RECOMMENDATION NUMBER: 382

TITLE: SYSTEM FOR RECOVERY OF WASTE HOT
WATER HEAT ENERGY

Final Technical Review

FINAL TECHNICAL REVIEW
System for Recovering Waste Heat
ORNL No. 009925

DWG A-1

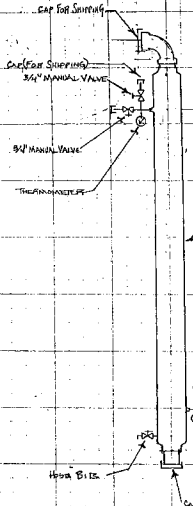
The governing health authorities may require a double-walled separation between the potable water and waste water. Approval from health authorities must be acquired before finalizing the design and construction of the prototype heat exchangers. Mr. Pravda has suggested a double-walled HX design which satisfies this requirement. This HX design appears to be fairly simple and could be mass produced with current level of technology.

Before this product is marketed, approval must be obtained from local health authorities. It appears a double-wall separation will be required between the potable water and the waste water. Mr. Pravda has proposed a HX design with double-wall separation.
